Site Address: 30 Queens Road, Waterlooville PO7 7SB

Proposal: Demolition of existing garage and studio block, construction of detached four bedroom property with refuse and cycle storage and landscaping

Ref: APP/23/00834

a) Kitchen/breakfast room

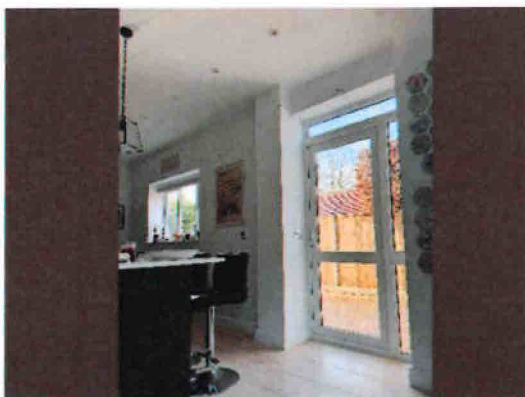
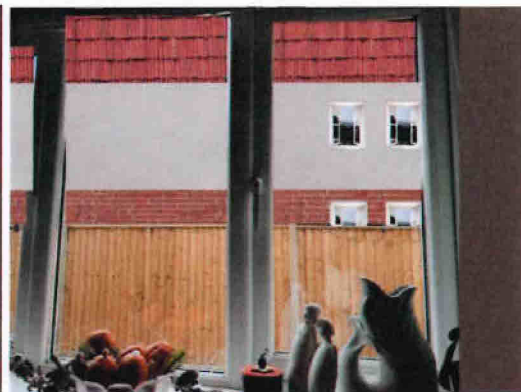
The west elevation of our property, 24 Queens Road, contains windows to areas of habitable, circulation and utility space. The proposed development would cause a substantial amount of shading/loss of daylight through these windows as the indicative annotated 'before and after' photographs below demonstrate (these cover habitable space only, although circulation and utility space would be similarly affected):

Figure 5.2: Daylight checking for new buildings adjacent to existing homes

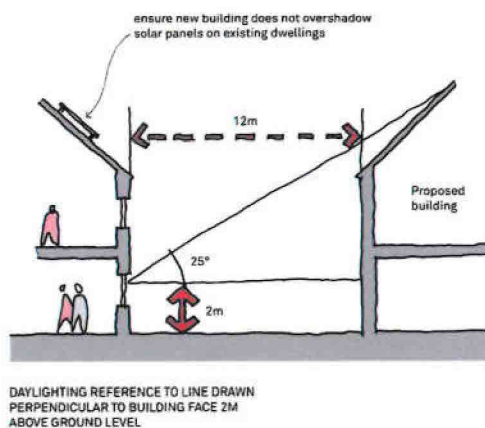
The Design & Access Statement sets out that the external walls of the proposed development would be 8.2 metres from windows to 24 Queens Road and only 2 metres from windows to 30 Queens Road, far less than the 10 metres minimum stated in the Design Guide. It is suggested that the application does not include a daylight/sunlight assessment for either of these properties because the results would prove unacceptable.

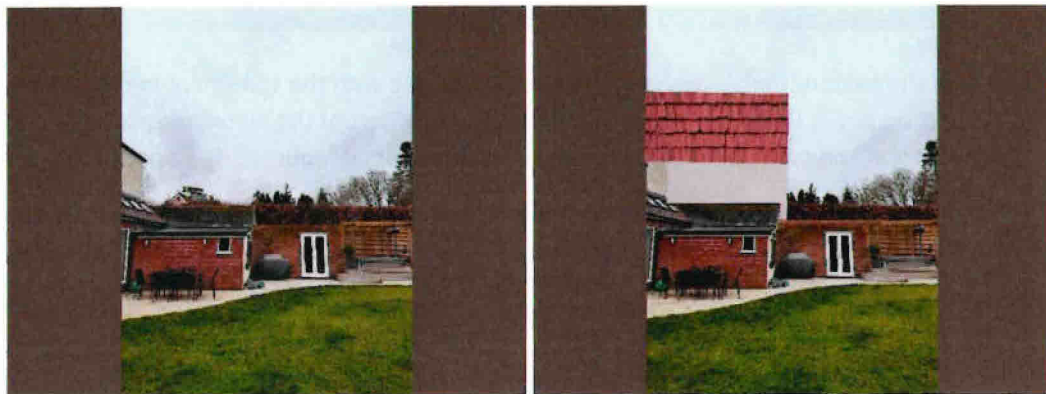
- i. Apart from the shading/loss of daylight referred to in 1. above, these rooms would also suffer from a loss of privacy due to the positioning of the ground floor 'playroom' windows and the removal of the beech hedge to the east elevation of the proposed development. This is demonstrated in the indicative annotated 'before and after' photographs in 1. above.
- ii. There would also be a loss of privacy in respect of our garden, from the first-floor windows of the proposed development in particular, as the indicative annotated 'before and after' photographs below show:

- iii. These photographs also demonstrate that the proposed development does not respect the 2-storey 'building line' to the back of the existing adjacent properties, making it overbearing in appearance and further reducing the privacy of the gardens to the properties either side.

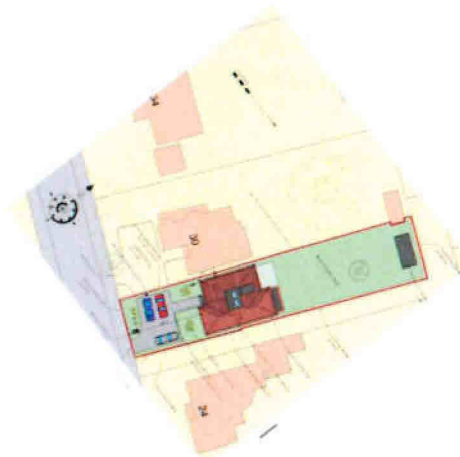
The proposed development does not respect this established building to plot width ratio as the extract from the planning application below clearly shows:

Instead, the application involves the proposed property being 'squeezed' into a narrow plot that is only 2 metres away from the east elevation of 30 Queens Road and 1 metre away from the proposed site boundary the other side. This causes the proposed development to be out of scale or balance to the other properties in its vicinity, thereby compromising the character of the road and the properties within it.

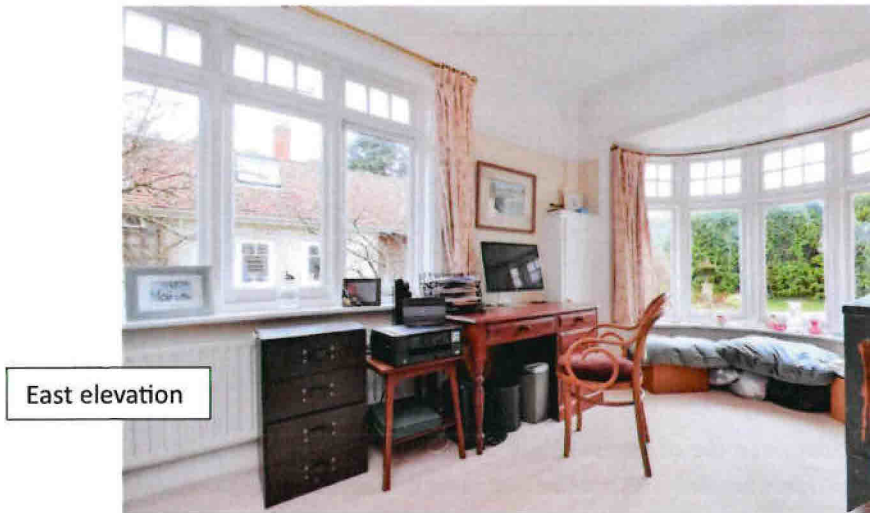
- ii. The proposed development also severely compromises the existing 30 Queens Road, a fine property of unique character and identity for the area as the photographs below clearly show; a house and gardens treasured by the inhabitants of Queens Road and Waterlooville in general:

A particular example of the severely detrimental impact the proposed development would have on 30 Queens Road is that the east elevation windows, including those to the study, utility room and a bedroom would look directly out at a 2-storey brick and rendered wall just 2 metres away. This will reduce significantly the amount of sunlight and daylight entering all rooms with east elevation windows including those referred to above. The east elevation is shown from the outside in the photograph below:
